**CERTIFICATE OF APPROPRIATENESS**

**Property:** 401 Sul Ross Street, Lot 3, 4, and 5 Block 18, Bute Subdivision. The property includes a historic 3,376 square foot two-story residence situated on a 9,375 square foot (75' x 125') corner lot.

**Proposal:** Alteration – Re-clad and add windows to an existing front and side addition

**SOUTH (REAR) ELEVATION**

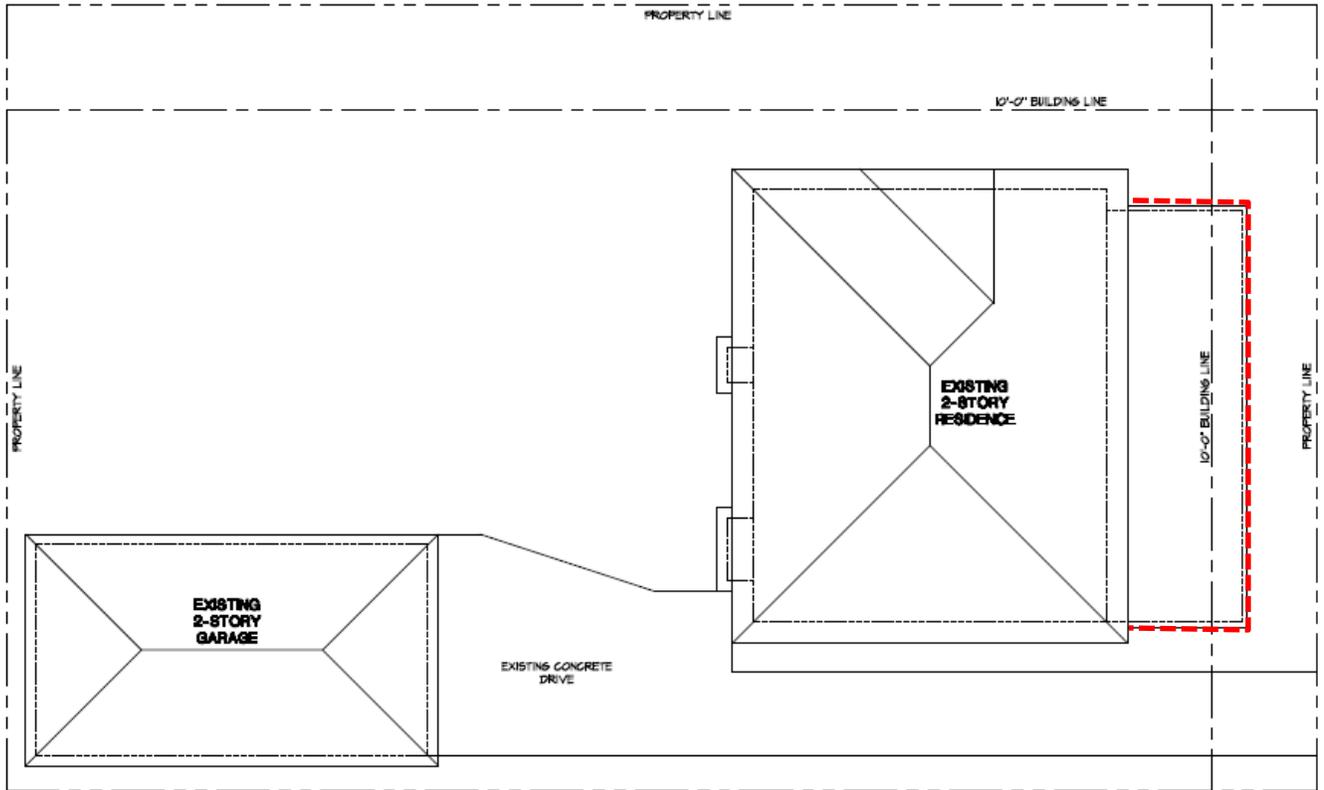
**Shape/Mass:** Existing residence features a one-story addition along the Bute Street (east) side of the property. The applicant proposes to alter the fenestration, re-clad the exterior, and add a 2' tall parapet wall to the roof of the addition.

**Windows/Doors:** The addition features 5 wood casement windows along the east elevation and a wood door along the north. The applicant proposes to replace this fenestration pattern with a row of sixteen 32" wide by 74" tall one-over-one wood recessed mounted double hung windows. Rows of 3 windows will face the north and south and a row of 10 will face the east.

**Exterior Materials:** Existing vertical wood siding will be replaced with smooth finish cementitious panels. The panels will be arranged to create 5 pilasters.

**Roof:** A 2' tall cementitious clad parapet wall will be added along the perimeter of the roof of the addition.
